Delegated Report		Analysis sheet	Expiry Date:	21/07/2016
		N/A	Consultation Expiry Date:	
Officer			Application Number(s)	
Tessa Craig			2016/2958/P	
Application Address			Drawing Numbers	
45 Goldhurst Terrace London NW6 3HB			See decision notice	
PO 3/4	Area Team Signature	C&UD	Authorised Officer Signature	
Proposal(s)				
Retrospective application to retain works to loft conversion (including rear roof dormer and terrace and enlarged side elevation dormer), removal of pitched roof of existing first floor projection and fenestration works including double access doors at upper ground floor rear elevation.				
Recommendation(s):		Refuse retrospective planning permission		
Application Type:		Full Planning Permission

1.1 Under application 2015/5564/P planning permission was granted in November 2015 for:

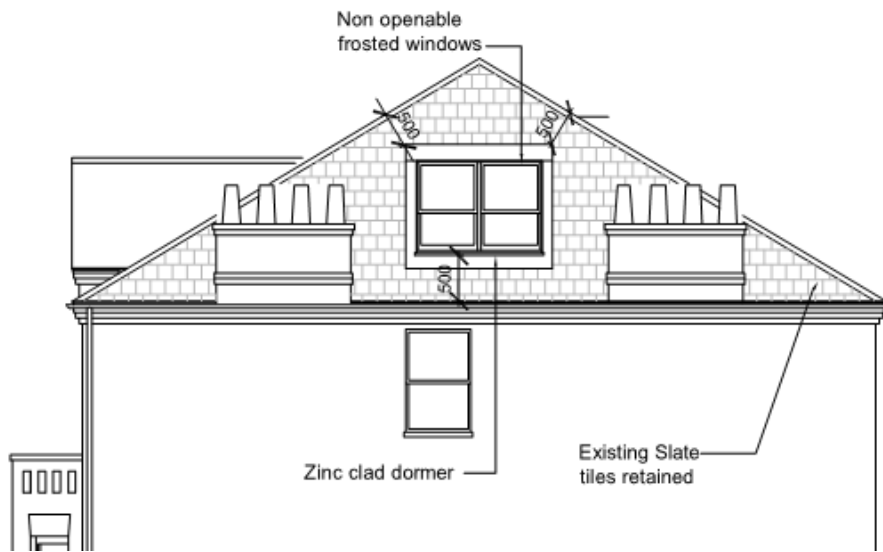
- 2.5 The as built side elevation roof dormer is overly large, inappropriately designed and does not relate to the lower floor windows, nor does it reflect the conservation area and is overly visible from the streetscene making it harmful to the conservation area. The side dormer has the appearance of a 'shed-like' structure being added at roof level and is in no way sympathetic to or subordinate to the roofslope as required by design guidance.

1) Rebuild the side and rear elevation dormers and remove the roof terrace in accordance with the approved plans of planning permission 2015/5564/P (including the railings) and reinstate the rear sloped roof of the ground floor projection, and make good any damage to the original building.

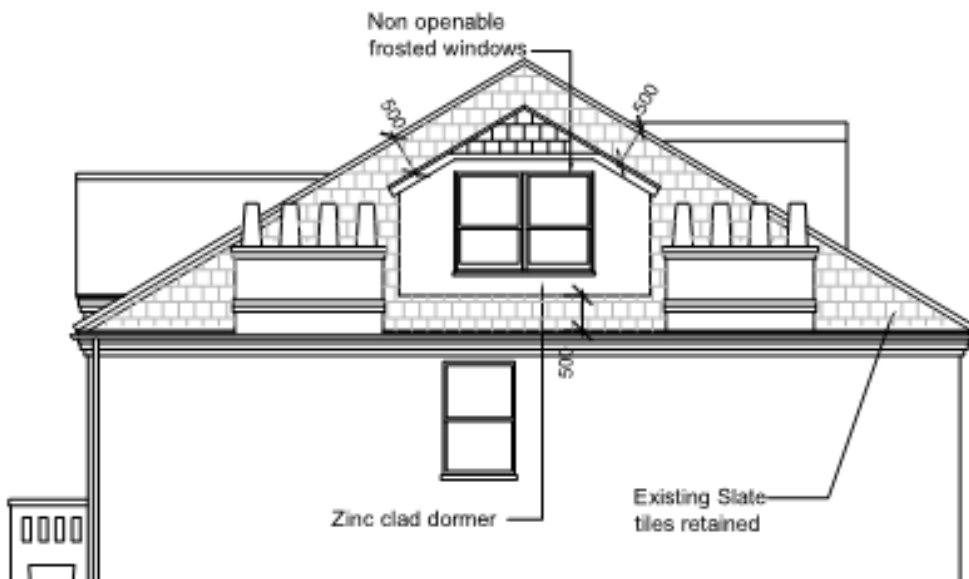
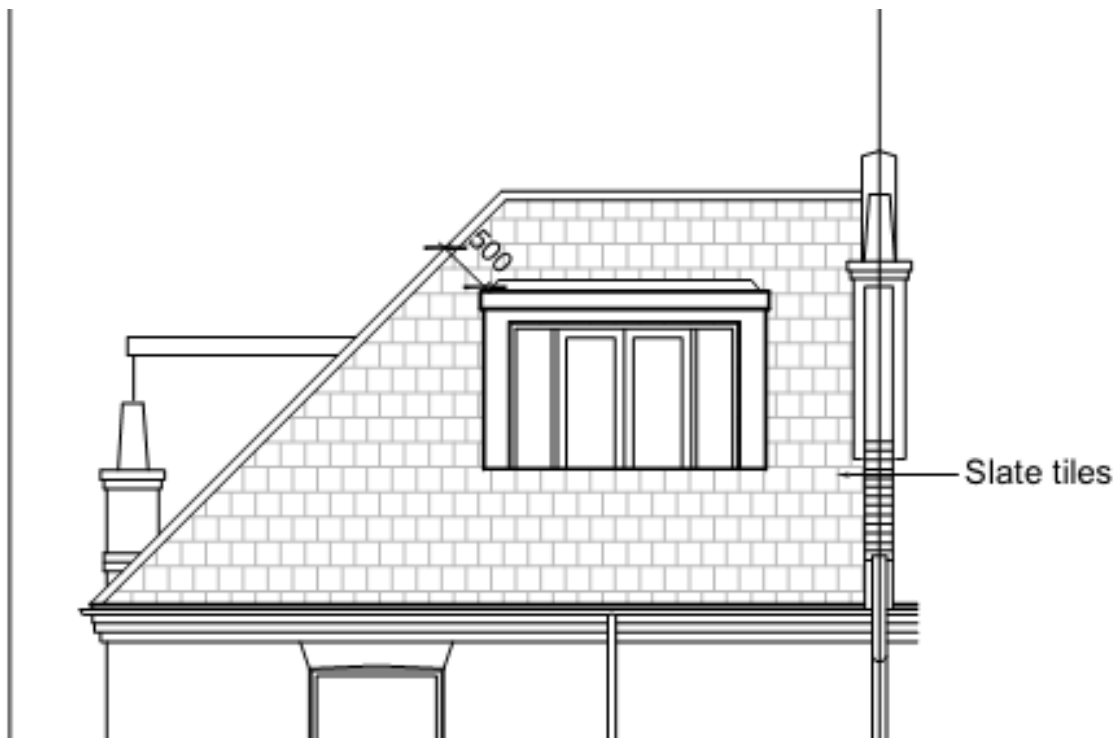
- 2.6 The as built rear roof dormer dominates the rear roof slope and includes an excessive roof terrace. The rear dormer and terrace fails to comply with the design guidance (it is not 500mm from all roof edges and nor is the terrace set within the roofslope- the railings protrude).The dormer and roof terrace is unsympathetic to the host property and is considered harmful to the conservation area. The applicant has suggested similar dormers nearby set a precedent for the dormer that has been built at the subject site, however nearby dormers are historic and either did not gain planning permission or were built prior to the current policies and guidance.

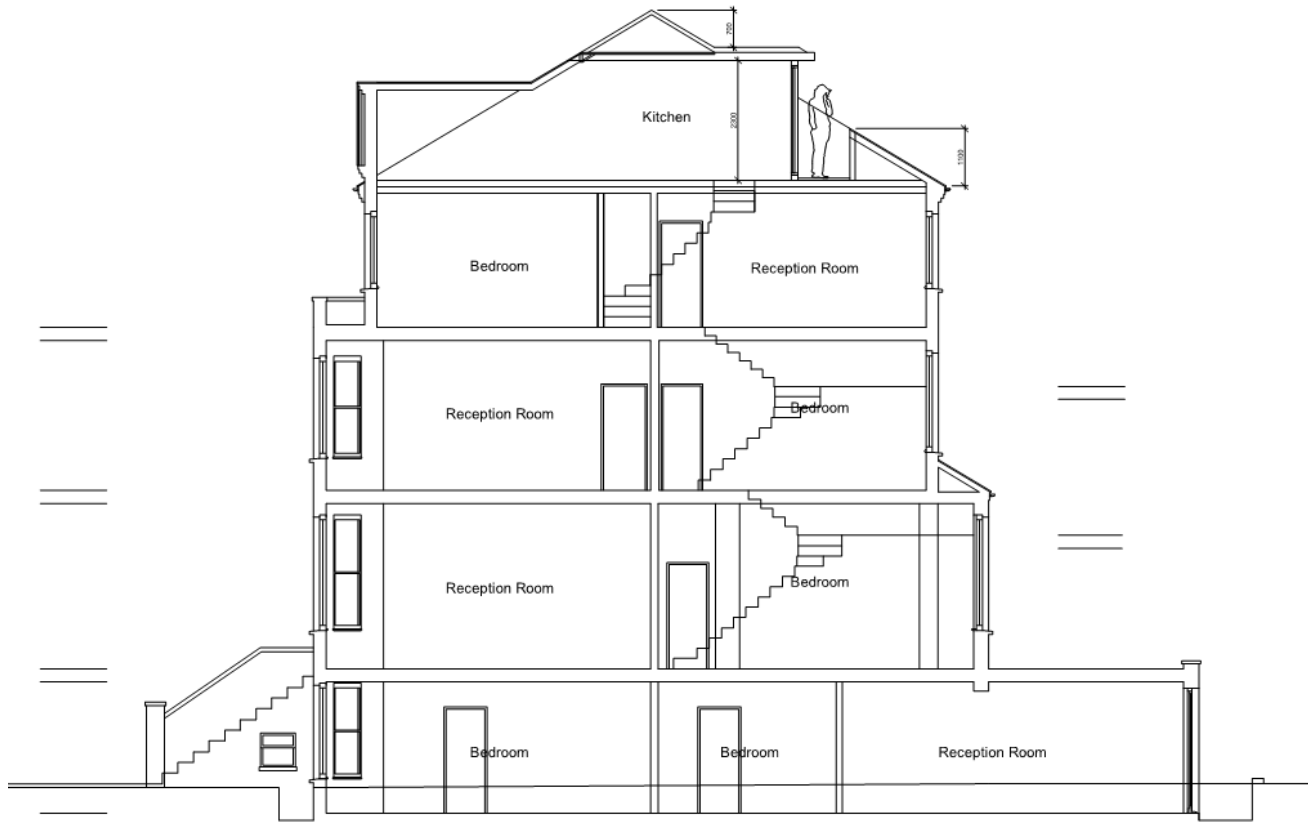
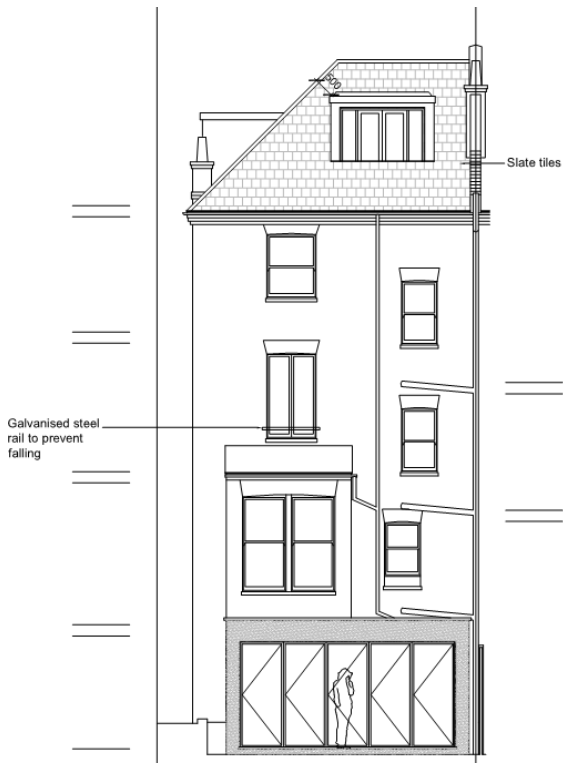
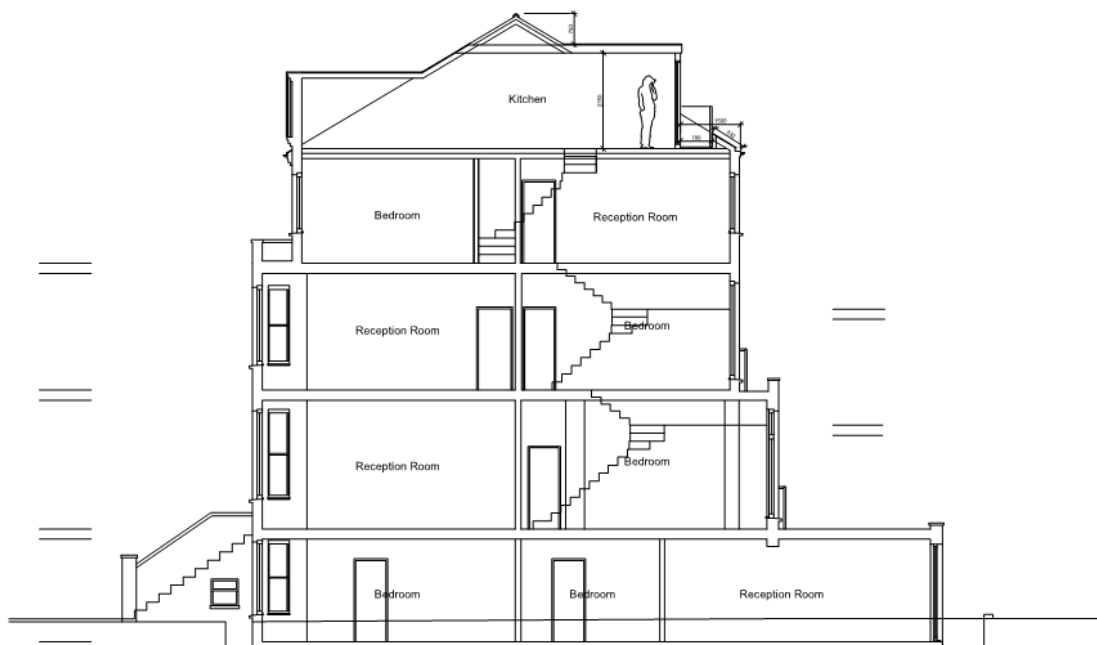
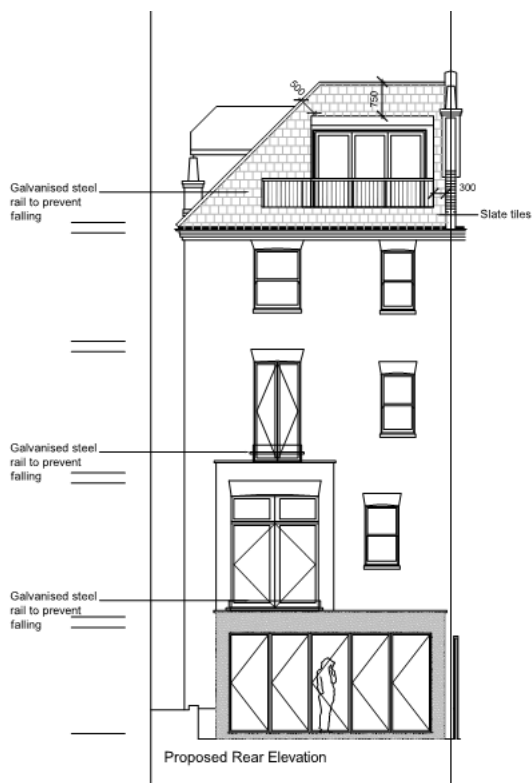
- 2.7 Installation of double doors at the ground floor rear elevation is considered inappropriate and unsympathetic to the property and has resulted in the loss of traditional sash-style windows. The presence of access doors in the rear elevation also means there is potential for the roof to be used as terraces particularly as the ground floor projection has had the roof flattened out. This is further addressed in the amenity section below.

2.10 Whilst the only terrace which has been established is the terrace within the rear roof dormer, the installation of double doors to the rear elevation and the flat roof of the ground floor projection means there is potential for the establishment of roof terraces. This is considered unacceptable in amenity terms given the potential for overlooking and loss of privacy to neighbours. There are no concerns regarding amenity in terms of the rest of the as built development.
